# **Addendum No. 1**

## **PORT OF BROWNSVILLE ANCHOR PARK**

January 29, 2021

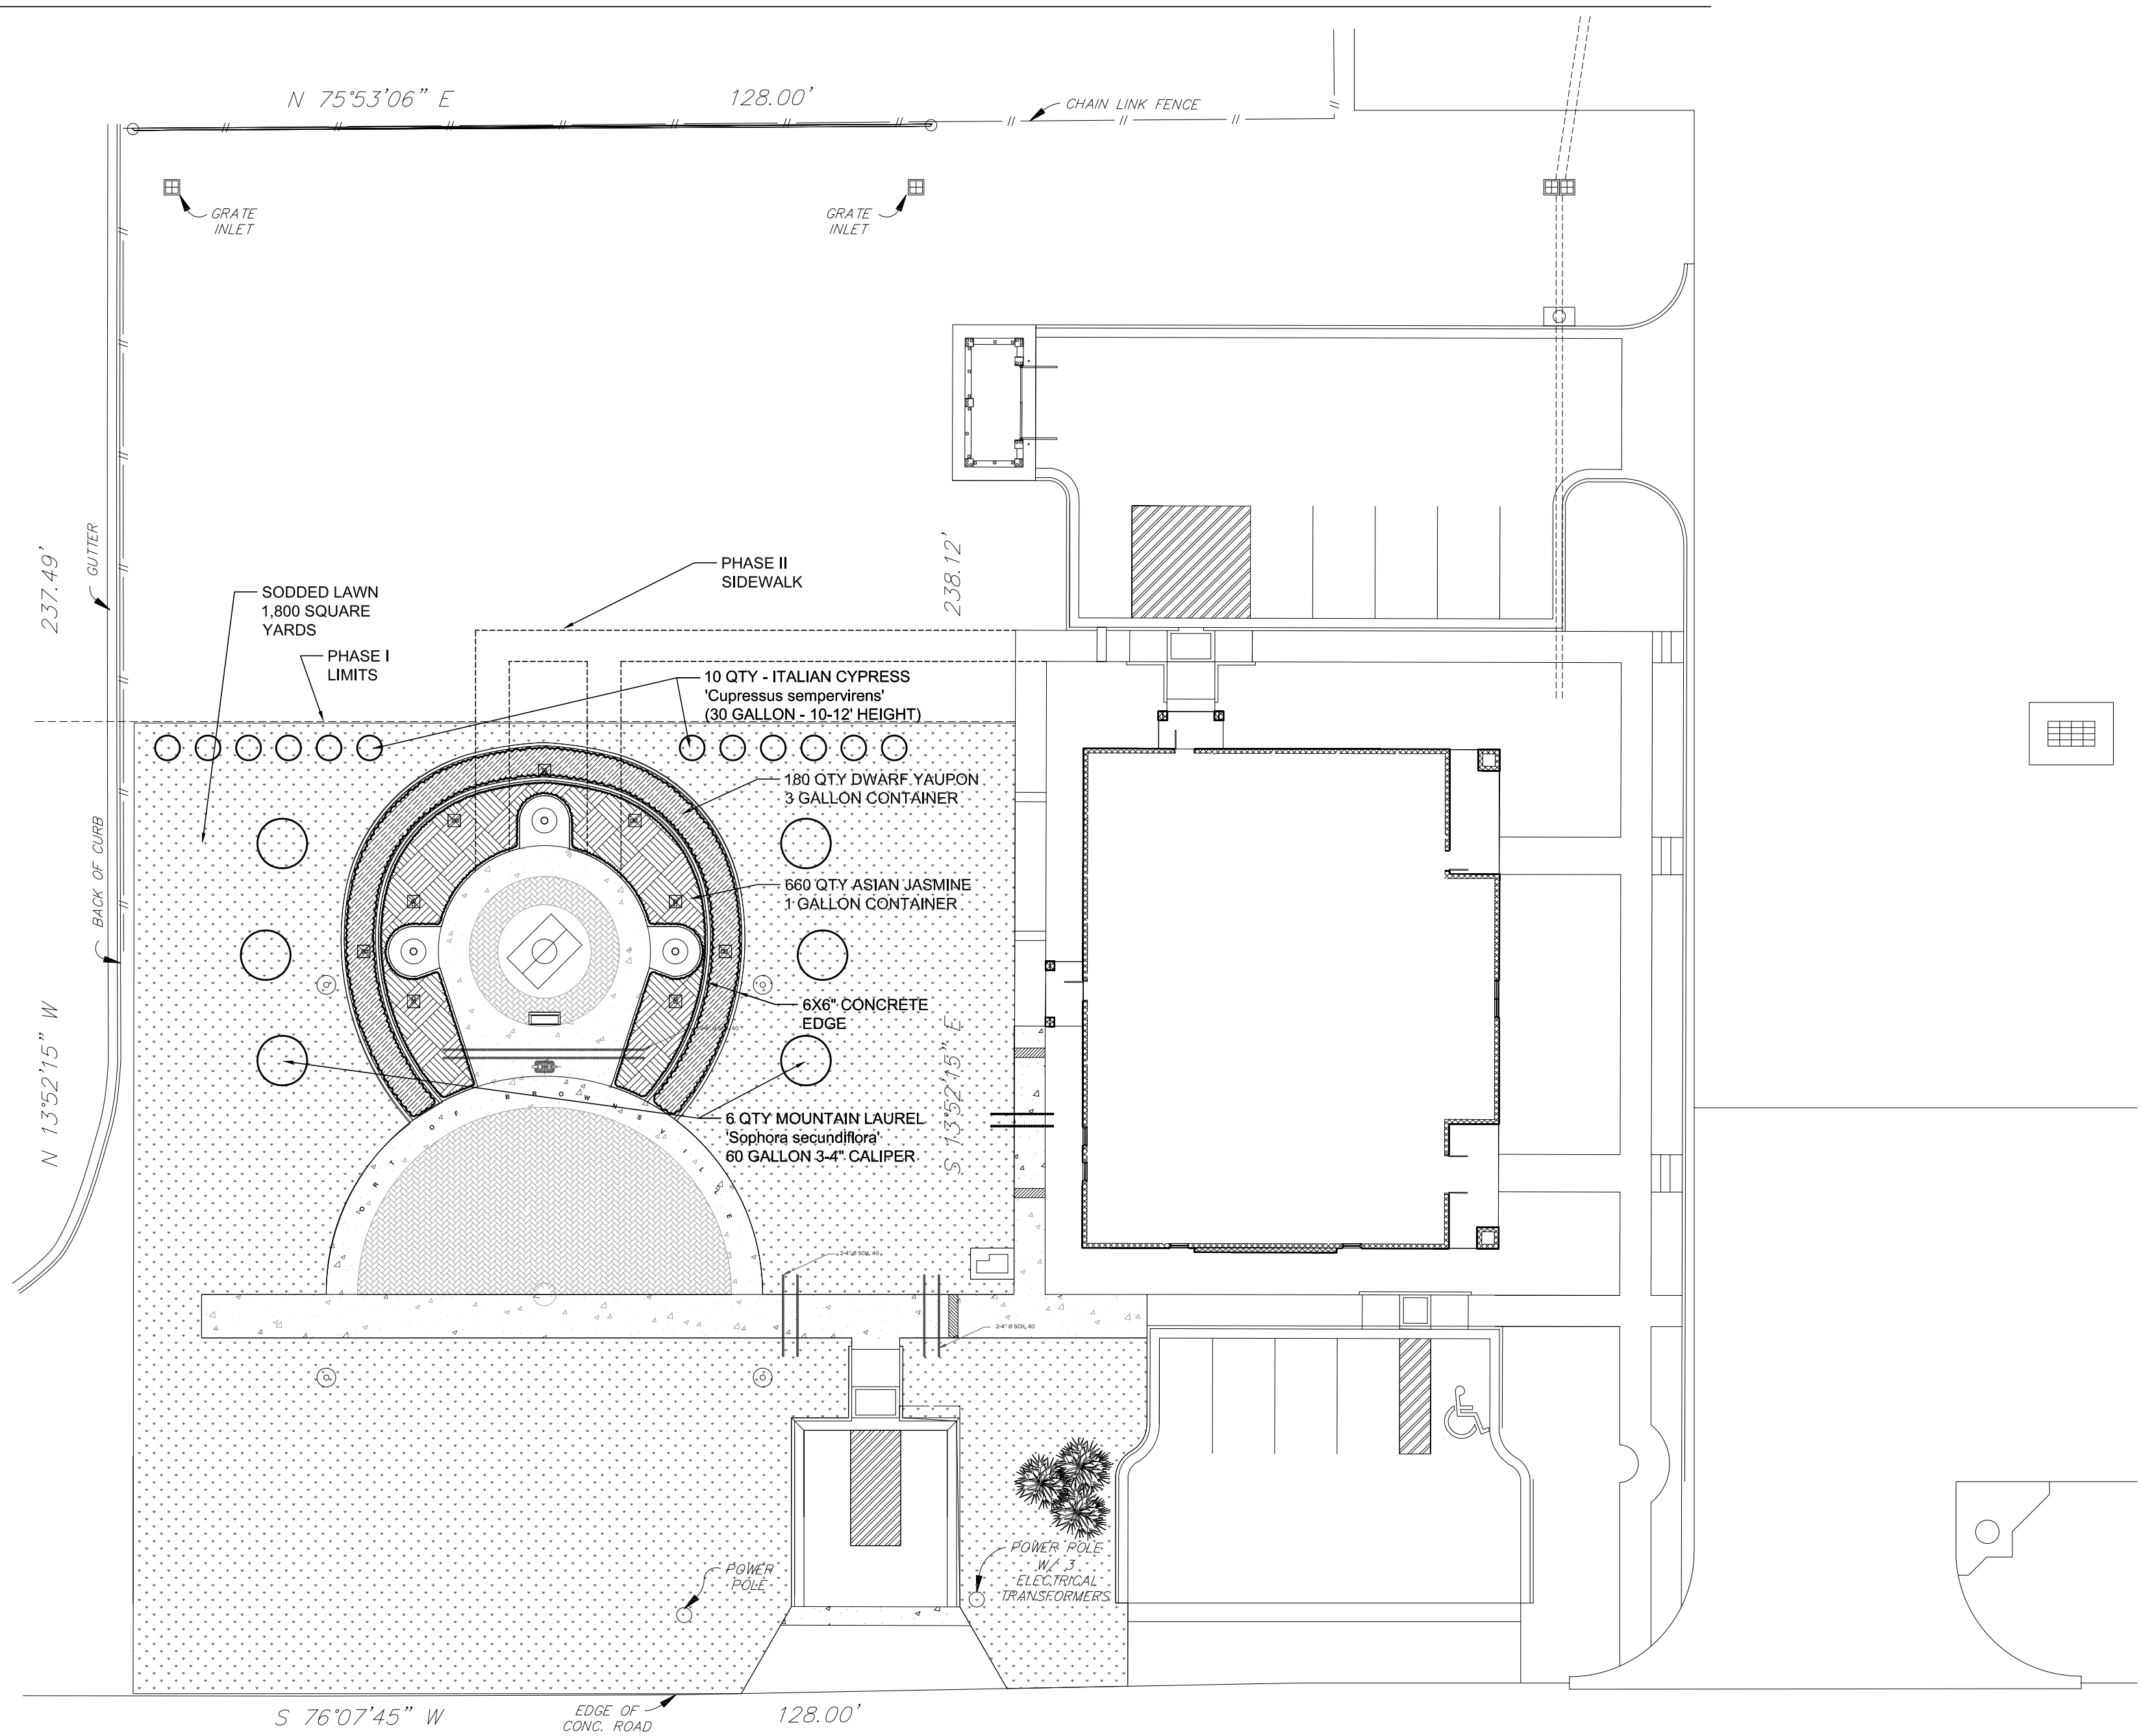
1. **ADDITIONS TO CONSTRUCTION DRAWINGS: LANDSCAPING**

- a. The attached drawing depicts the proposed landscaping improvements for the Anchor Park project. Contractors are encouraged to review and familiarize themselves with this layout.
- b. An Addendum will be issued to elaborate on the description of the proposed improvements and the associated landscaping as well as the budget provision for these endeavors.
